SUBJECT: Forwards responses to open items & questions which will become part of Amend 23 distribution, per 801107 ltr.

Subject: Docket Nos. 50-361 and 50-362  
San Onofre Nuclear Generating Station  
Units 2 and 3

## RESPONSES TO NRC OPEN ITEMS

San Onofre Nuclear Generating Station  
Units 2 and 3

Table 121.23-1

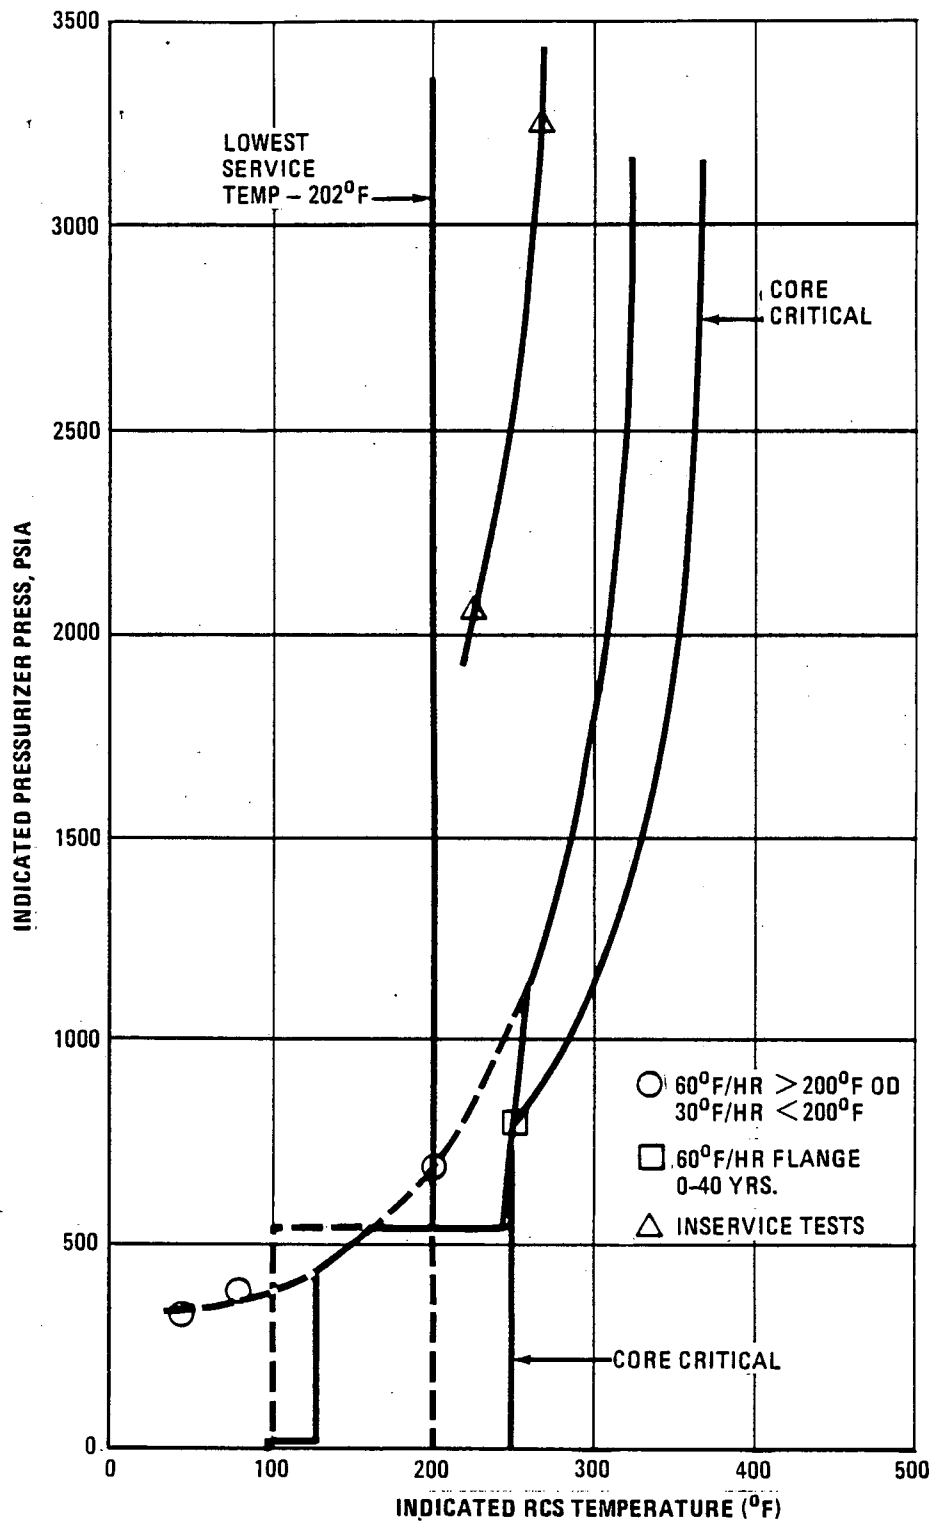
Revise the pressure-temperature limits, presented in Figures 16.3-7A and 16.3-7B of the Technical Specifications, to reflect data requested in Question 121.19.

Revised pressure-temperature curves for San Onofre Unit 2 have been provided (figures 16.3-7A and 16.3-7B). Revised curves for Unit 3 will be provided later. Table 121.23-1 is provided to show heatup, cooldown, and limiting material data.

FIGURE 212.164 - 1

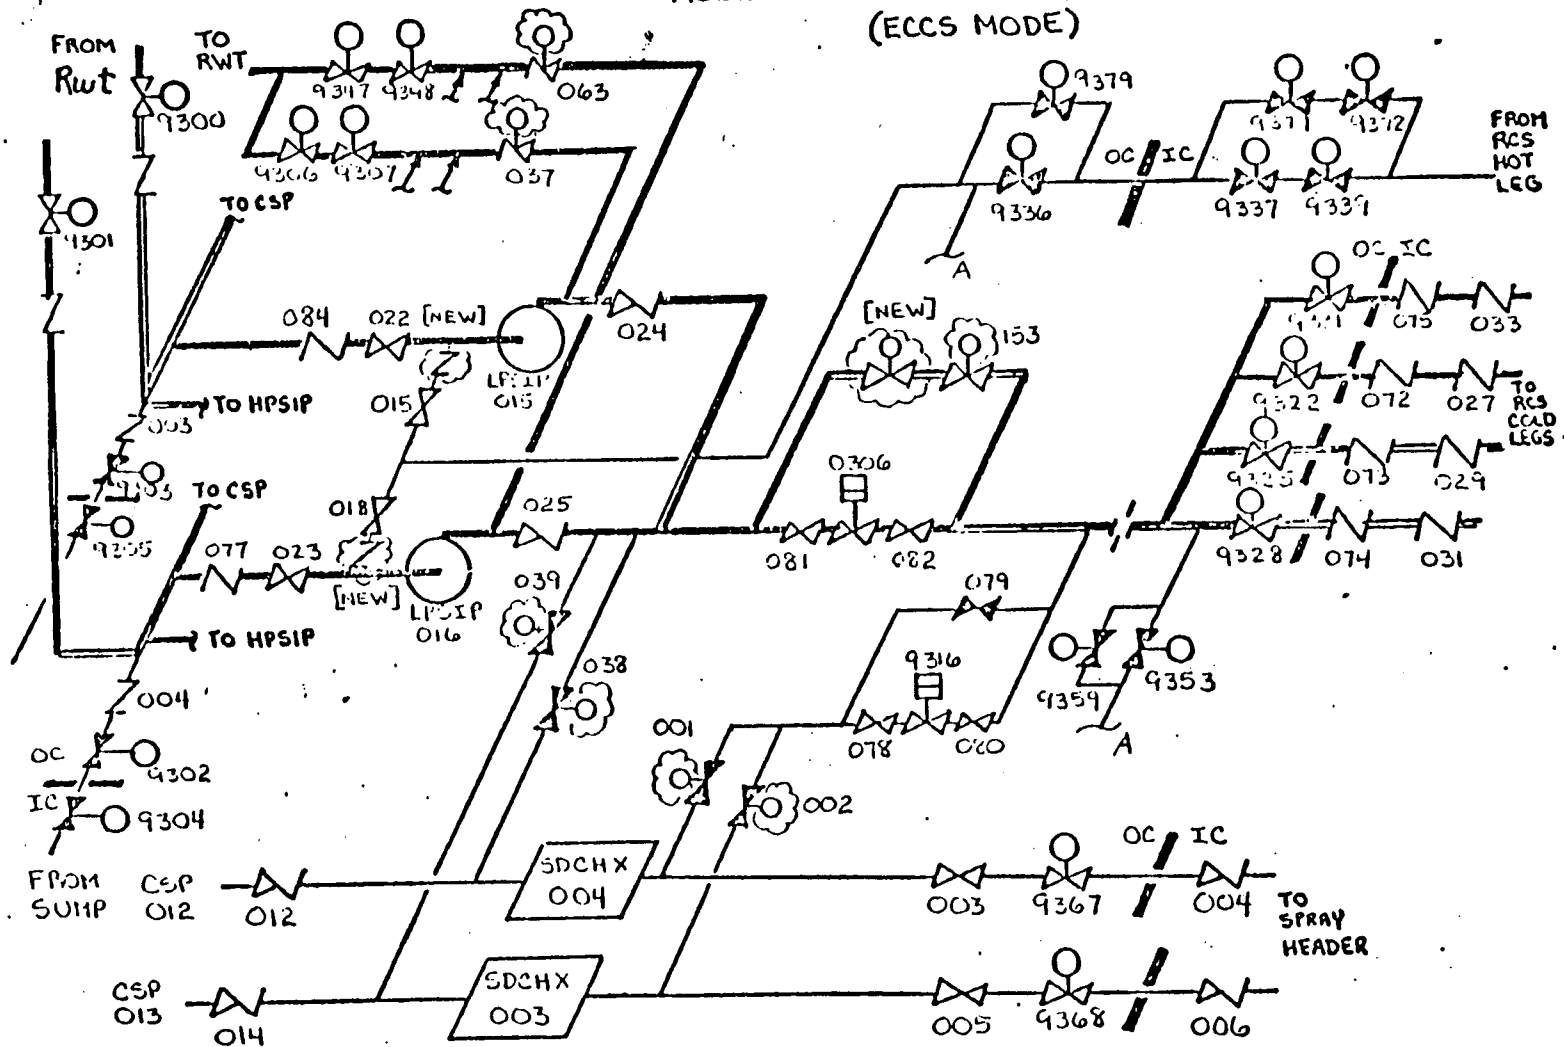
The staff has reviewed the shutdown cooling system design of San Onofre 2 and 3 for compliance to Reactor Systems Branch Technical Position 5-1 (as to be implemented for Class 2 plants). We have concluded that your present design does not meet that part of BTP 5-1 which requires the operator to be able to bring the plant from normal operating conditions to SDCS entry from the control room. It is our understanding that at least nine (9) valves in the SDCS train need to be manually repositioned from outside of the control room in order to realign from the safety injection to the SDC mode of operation.

It is the staff position that the SDCS design of San Onofre 2 and 3 be revised to comply with the above. We request that you submit the appropriate documentation of your design revision for staff approval prior to installation. Included in your submittal should be an evaluation which demonstrates that the modifications made do not significantly reduce the reliability of ECCS.

A simplified flow diagram showing the proposed SDCS hardware modifications is given in figure 212.164-1. The manual valves which originally required local manual operation to initiate shutdown cooling are identified in table 212.164-1. The hardware modifications that are proposed to eliminate local manual actions are summarized in table 212.164-2. The flow diagram, figure 212.164-1, illustrates operation of the shutdown cooling equipment in an emergency core cooling mode. It is important that the proposed modifications do not significantly affect the emergency core cooling function.

Three areas where modifications have been made involve the system boundary. First, the low pressure safety injection pump minimum flow isolation valves 063, 037 were considered. Motors will be added to these valves. During normal operation these valves must be open; during shutdown cooling they are closed. Provisions will be provided to remove power from the valve during normal operation to prevent spurious closure. Therefore, no adverse effect on ECCS operation results from this modification. Next, changes at valve 015 and 018 were considered. These valves were normally closed to provide suction line separation in the emergency core cooling mode of operation. This is desirable to prevent return of sump fluid to the RWT under selected single failures. Under the modified system the valves remain open and check valves are added to provide the separation. The remaining boundary area is the set of isolation valves around the shutdown cooling heat exchangers. These are valves 039, 038, 001, and 002; they function to separate the containment spray system from the ECCS. Motors are to be added to these valves. A single failure resulting in the opening of one of these valves will not result in the loss of ECCS flow and will have an effect on only one spray train. Therefore, power removal was considered

The final area of change that has the potential to influence emergency core cooling performance is the area around the flow control valve 0306. A summary of the intended functions is provided on table 212.164-3. During normal power operation and during ECCS operation, all valves in the 0306 and 0306 bypass segments will be open and power will be removed. The 0306 valve will have its failure position changed to fail open. For the purpose of evaluating system performance, this arrangement is considered passive and does not affect system availability.
